ADDENDUM

Date Issued:	January 11, 2022
Project:	Intermountain Healthcare IMC- Cath Lab #3 Remodel 5121 South Cottonwood Street Murray, Utah 84107
Addendum Number:	1

Demolition Floor and Ceiling Plan - Level 1

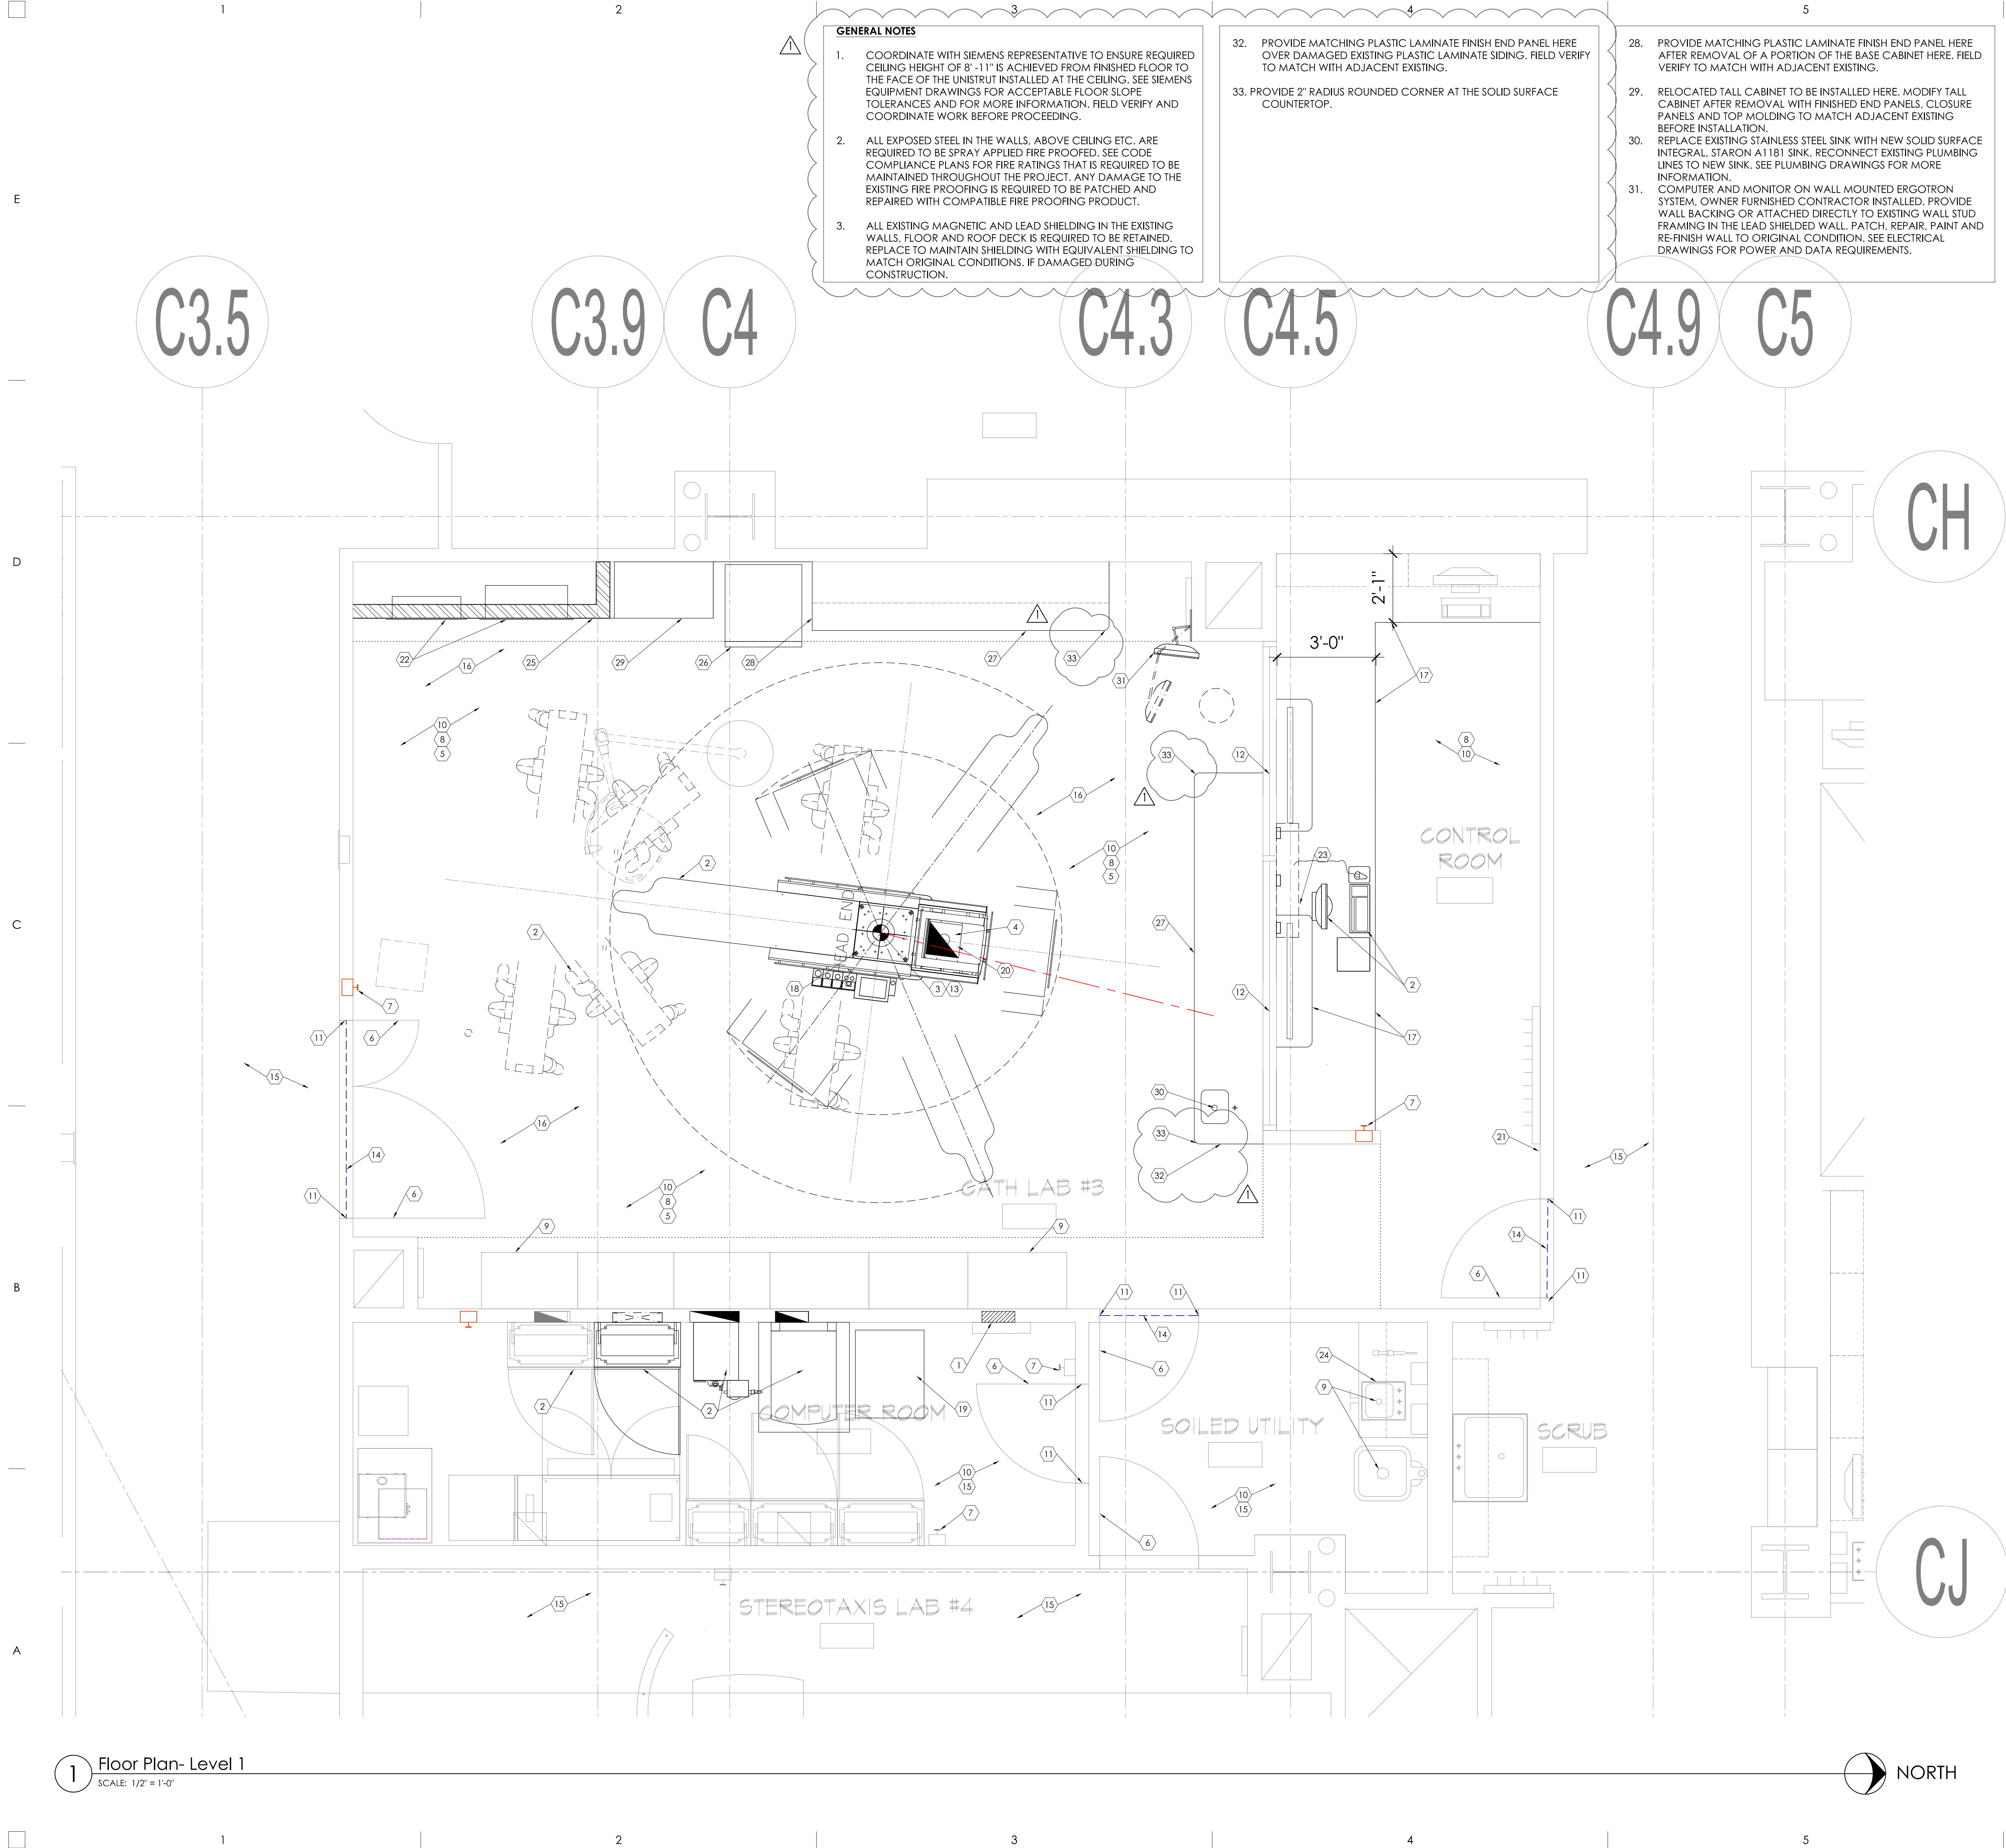
Sheet Number	Drawings
Architectural	
A101	See attached revised sheet with revisions shown clouded.
A111	See attached revised sheet with revisions shown clouded.
A131	See attached revised sheet with revisions shown clouded.
A151	See attached revised sheet with revisions shown clouded.
A502	Detail added to the sheet A502. See attached sheet with revisions shown clouded.
